REPORT
TO THE
MIDDLETOWN COMMISSION
ON THE
CITY PLAN AND ZONING

SAWMILL BROOK RACE COURSE

MIDSTATE REGIONAL PLANNING AGENCY
MARCH 13, 1974

**EROSION HAZARD -
CUBIC YARDS PER ACRE
PER YEAR**
LEGEND

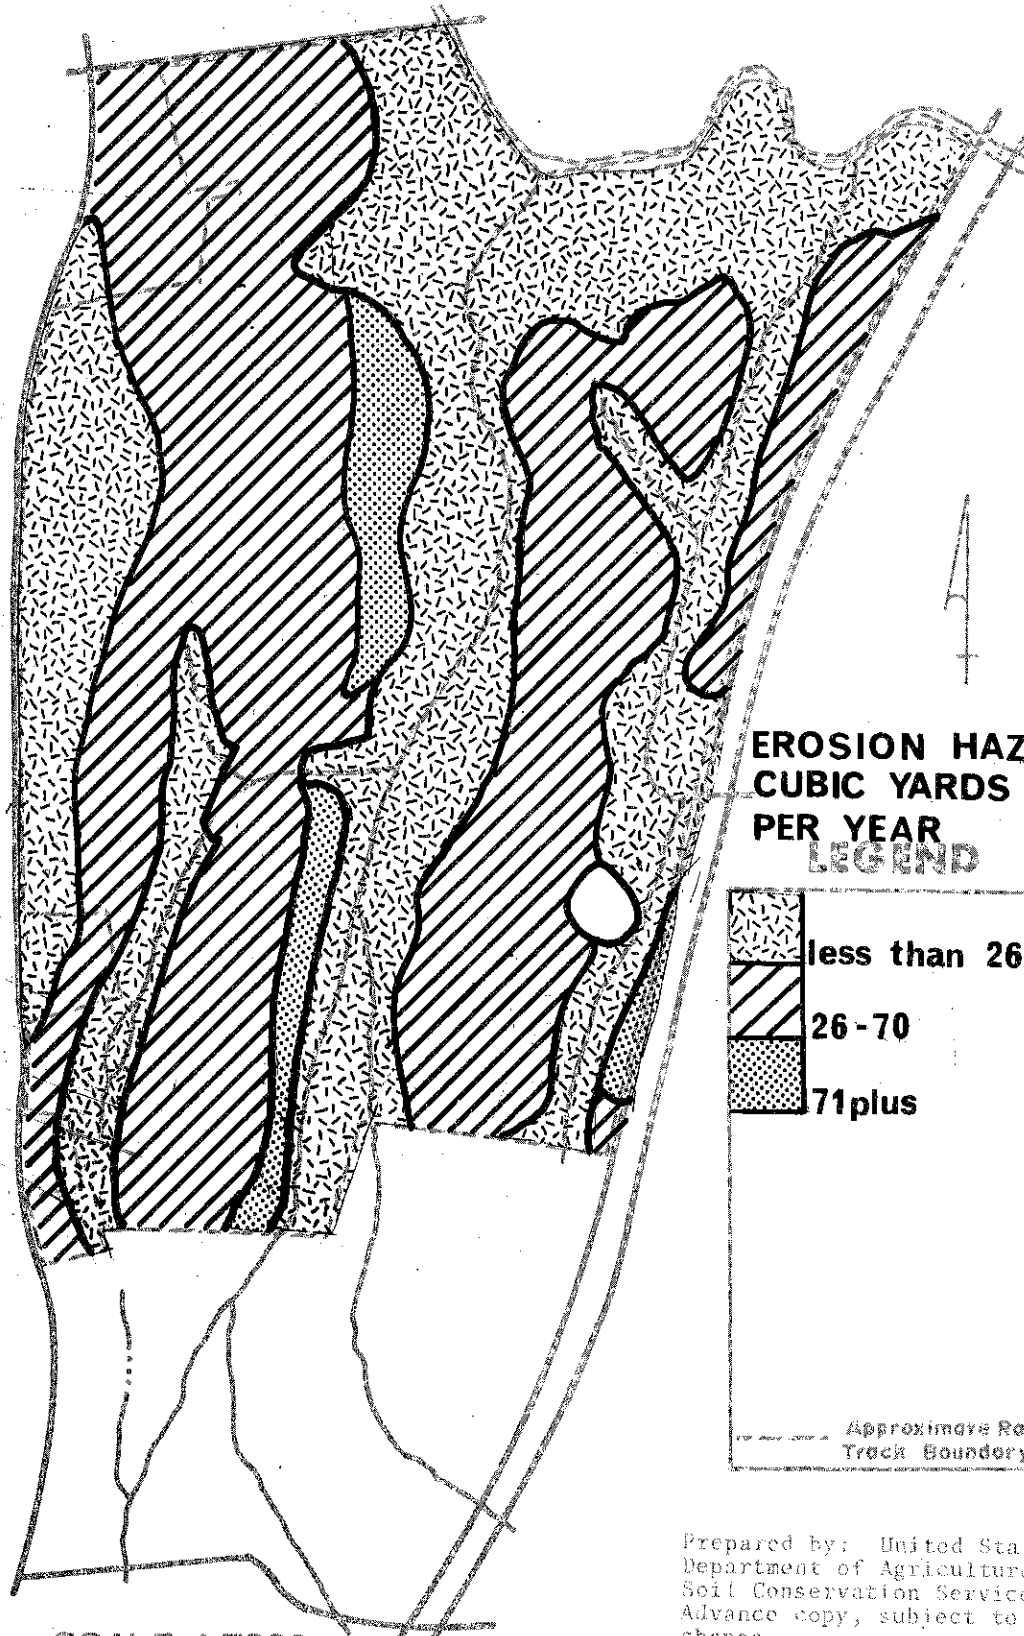
The following map graphically depicts the erosion hazard of the soils on the proposed site.

FILL AND EXCAVATION AREAS

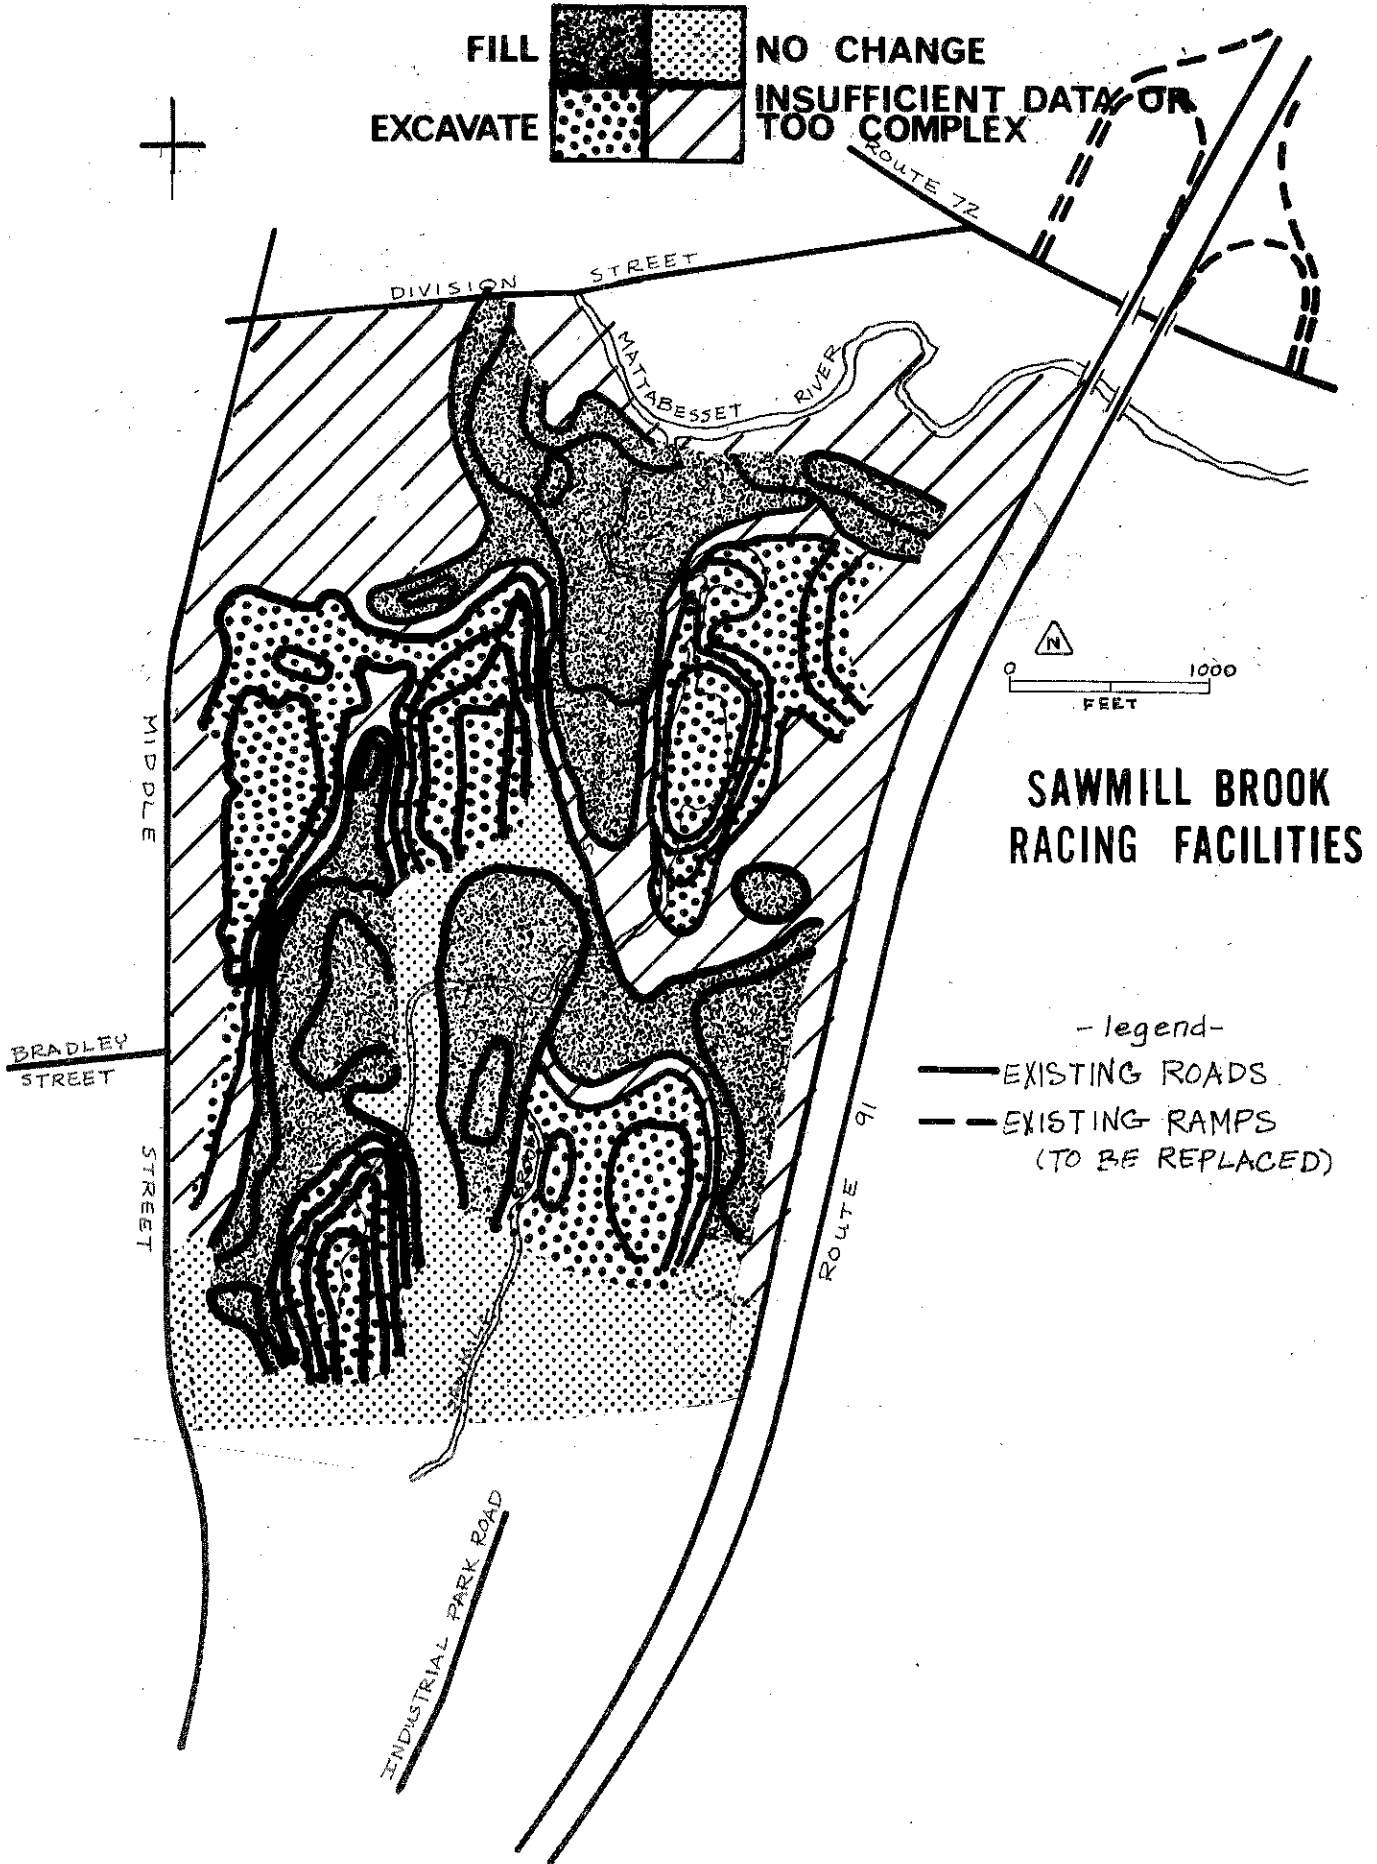
For publication purposes this data was summarized into broader categories. It is important to understand that these maps are general and were developed only to give a visual impression of the extent of change in the land surface. The maps are not necessarily accurate at any given location.

The extensive amount of proposed excavation, considerable topographic relief, character of the ground materials and the proximity of a through-flowing stream all indicate the potential of a major erosion and sedimentation problem during construction with potential significant effects on the Mattabesset River and the marshes at this river's mouth. The amount of proposed excavation is large. Virtually all areas of the site will be regraded, excavated or filled.

Local topographic relief is as much as 130 feet with moderate to steep slopes over much of the western two-thirds of the site. Much of the site is underlain by till, and samples of this material from the Cromwell/Rocky Hill areas indicate that from 30% to 80% of this till contains particle sizes less than 0.02 mm in diameter. Particles this small will not settle out in sediment ponds where current velocities exceed 0.1 cm/second. The through-flowing brook will tend to carry much of any eroded material off the site and into the Mattabesset River for

Measures for erosion and sediment control should be designed to prevent erosion before it starts and to isolate totally sediment-laden runoff from Sawmill Brook. The potential for erosion and sediment problems on this site is so great that a specific and detailed plan for control should be developed before construction is approved or begun. The control program should greatly exceed normal consideration for this problem and should be designed to handle even infrequent but occasional heavy summer rain storms, insuring that no significant amounts of sediment are carried off the site by surface water. Adequate control will probably have to be achieved by carefully regulating and phasing construction activity to prevent erosion, and by totally isolating all surface runoff away from Sawmill Brook, directing this runoff to "dead end" sediment ponds which disperse water through evapotranspiration and infiltration.

All control measures should be completed prior to the start of construction.

In developing the site it is suggested that the area east of Sawmill Brook be graded first and the new channels and pond for the diversion of Sawmill Brook be completed. Then, before start of construction west of Sawmill Brook, the brook should be diverted permanently into its new channel. This procedure would minimize the amount of activity in the immediate vicinity of Sawmill Brook and allow for greater protection from sedimentation.

FIGURE 1

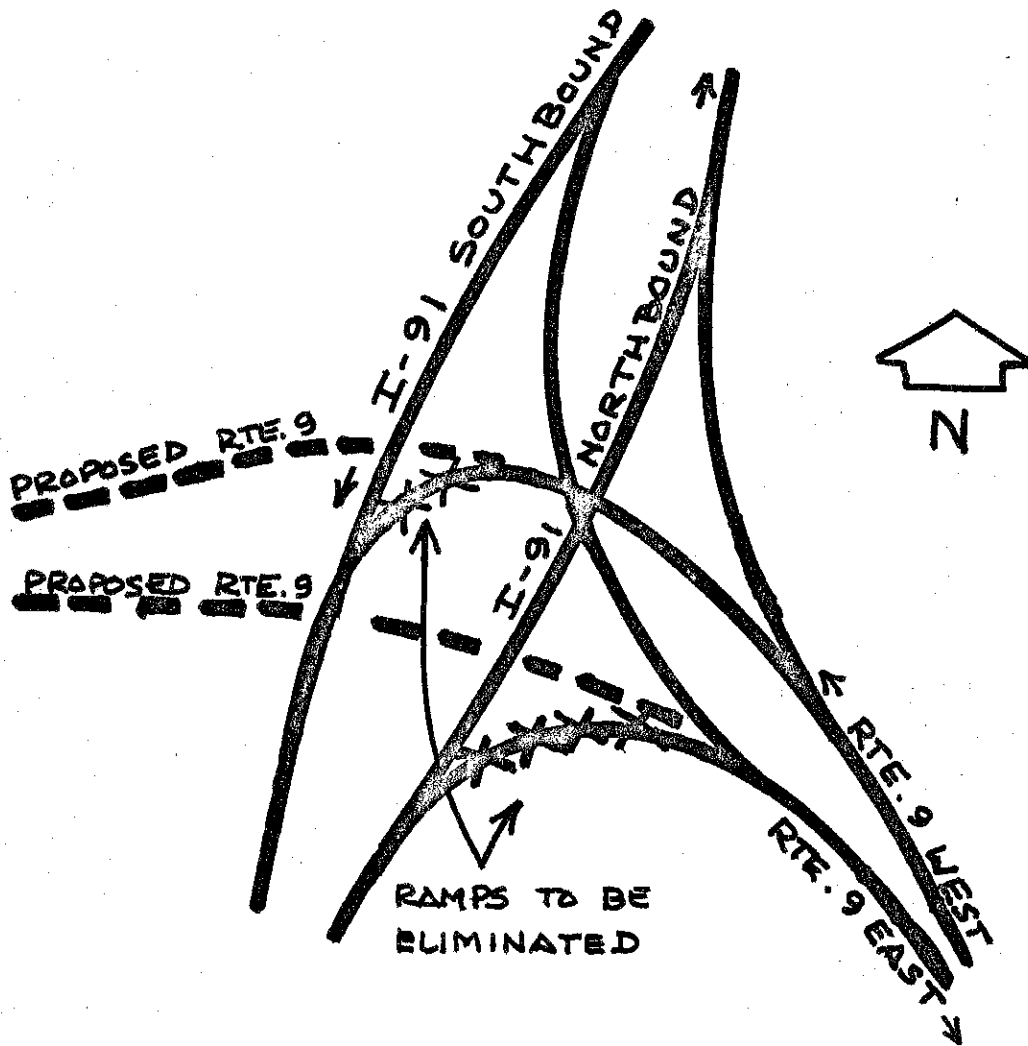
- 1) The traffic assignment data for local road systems, as shown in the report by Purcell Associates, does not conflict with the analysis conducted by CONN DOT's Planning Division. For purposes of analysis, the traffic assignments developed by CONN DOT and Purcell Associates were made assuming a limited interchange at Route 9 and I-91. (see figure 1).

A potential conflict with these assignments centers around the completion date for the Route 9 - I-91 interchange. CONN DOT has projected a completion date of fall of 1979 for the extension of Route 9 to the west to Route 15. Assuming that the race-track meets with the various approvals necessary, and could be finished by the fall of 1976, there would be a significant change in the traffic assignment as presented in the Purcell report.
